ADDENDUM NO. 1

Helen Sommers Building Atrium Closure
Washington State Department of Enterprise Services
Olympia, Washington 98122
Project No 2019-235 G (2-1)

NEW GLAZING SILL AT BALCONY REVISED

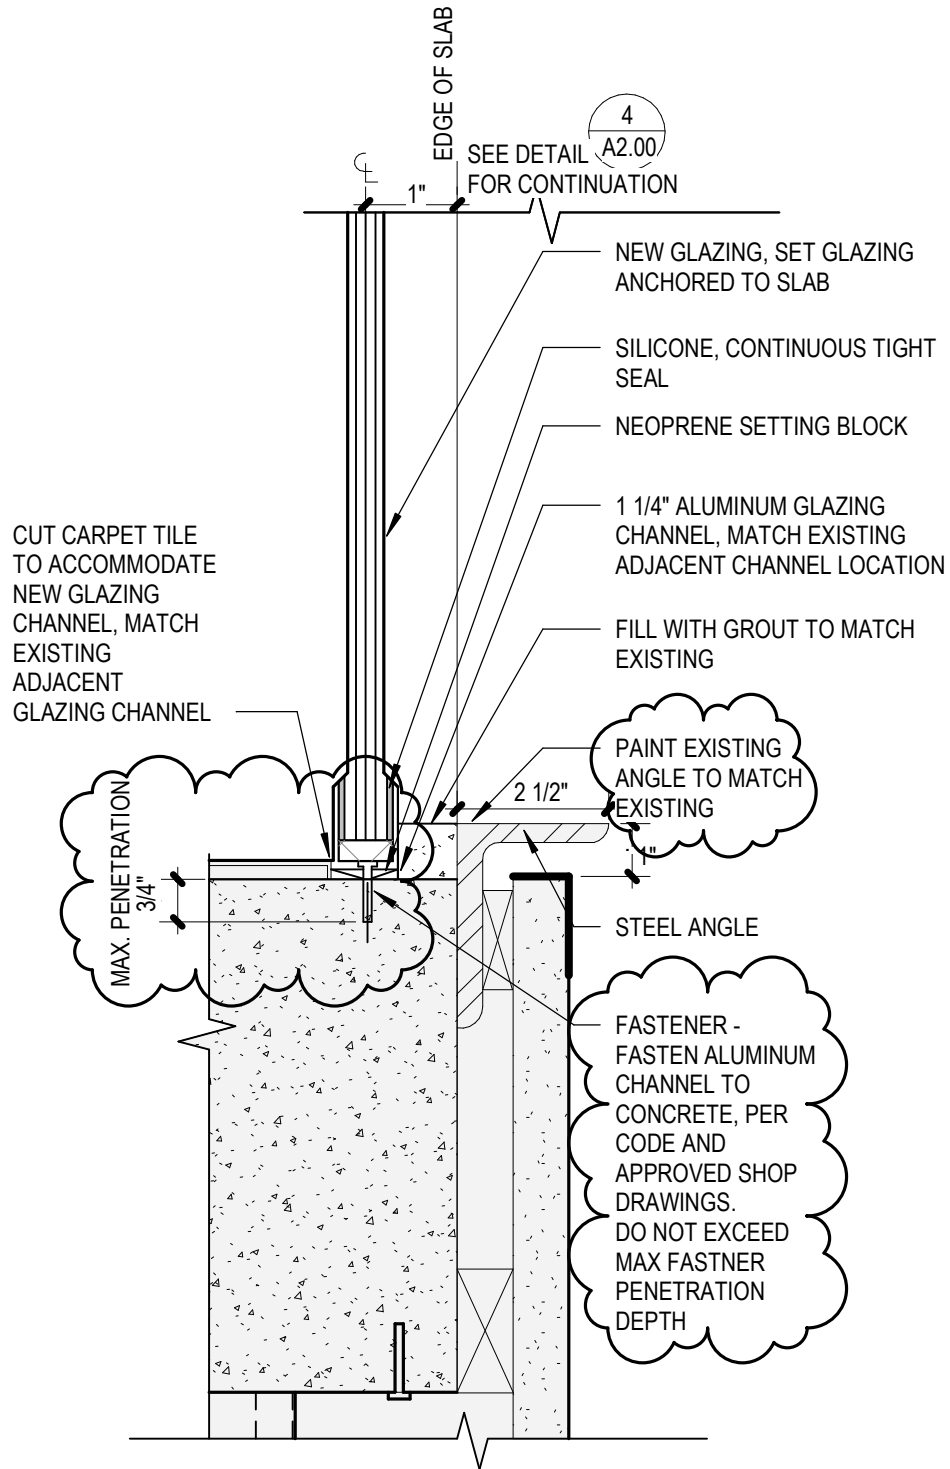
1. Revise detail 3/A2.00 per attached sketch SK-1.
